Work Order ID 88903

Item Name: Crosstube Assembly, Mid Fwd

DRAWING NO. D206-667-147	TITLE CROSSTUBE ASS'Y (206L MID FWD)	REV. A	DART AEROSPACE LTD ENGINEERING ORDER		D.E.O. NO. D206-667-147-A-1	SHEET NO. SHEET 1 OF 1	SCALE NTS
DRAWN DATE 11.07.15	CHECKED DATE 11.07.20	MFG. APPR. DATE 11.07.21	APPROVED DATE 11.07.21	DE APPR. DATE 11.07.21

PURPOSE:
REPLACE MAGNOBOND WITH PROSEAL.

DART AEROSPACE LTD HAWKESBURY, ONTARIO, CANADA	
DRAWING NO. D206-667-147	REV. A SHEET 1 OF 4
TITLE CROSSTUBE ASS'Y (206L MID FWD)	SCALE NTS

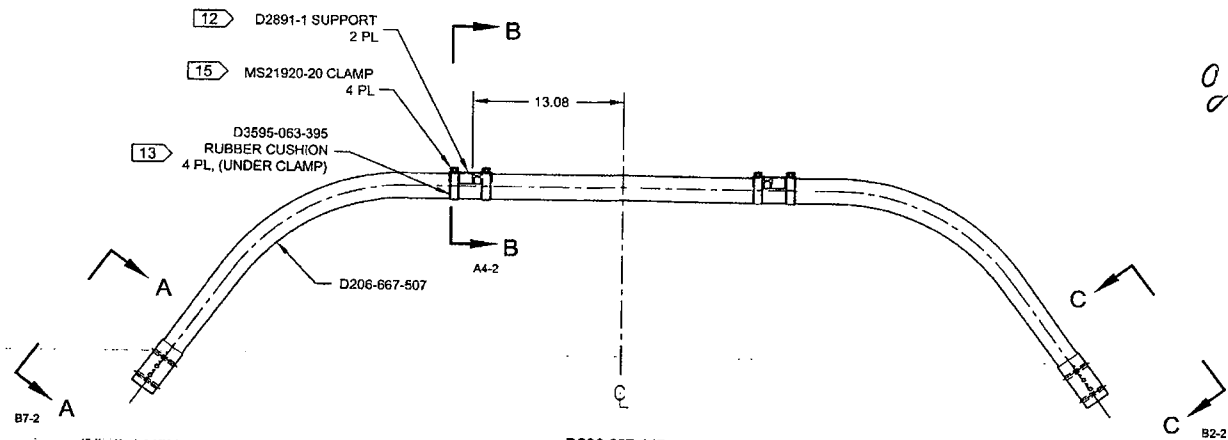
Item	Qty -147	Part Number	Description
9	A/R	PROSEAL 890 B-2	SEALANT, AMS-S-8802 CLASS B-2

9	A/R	MAGNOBOND 6398	ROCKWELL SPECIFICATION RBO-120-023 ADHESIVE (TEXTRON/BELL SPEC. 299-947-100, TYPE II, CLASS 2 ADHESIVE)
---	-----	----------------	---

NOTE 12 & 15, SHEET 1 IS AMENDED AS FOLLOWS:

- 12) TO INSTALL D2891-1 SUPPORT: ABRASE MATING SURFACE OF SUPPORT AND CROSSTUBE WITH 180-GRIT SANDPAPER AND REMOVE RESIDUE WITH MEK (OR EQUIVALENT). APPLY A 0.04" TO 0.07" THICK LAYER OF PROSEAL 890 CLASS B-2 (OR AMS-S-8802 CLASS B-2) SEALANT TO MATING SURFACE OF SUPPORT.
- 15) TORQUE CLAMPS 80 TO 100 IN-LB. ENSURE AT LEAST 1.5 THREADS SHOWING IN SAFETY AND THAT NUT HAS NOT BOTTOMED-OUT AFTER TORQUING. **PRIOR TO PACKAGING, RE-CHECK TORQUE ON CLAMPS AFTER PROSEAL 890 SEALANT HAS CURED FOR 72 HOURS.**

- 12) INSTALL D2891-1 SUPPORT USING 0.03" TO 0.06" THICK LAYER OF MAGNOBOND 6398 PER QSI 015. LET CURE FOR 12 HOURS AFTER INSTALLATION AND PRIOR TO PACKAGING.
- 15) TORQUE CLAMPS 80 TO 100 IN-LB. ENSURE AT LEAST 1.5 THREADS SHOWING IN SAFETY AND THAT NUT HAS NOT BOTTOMED-OUT AFTER TORQUING.
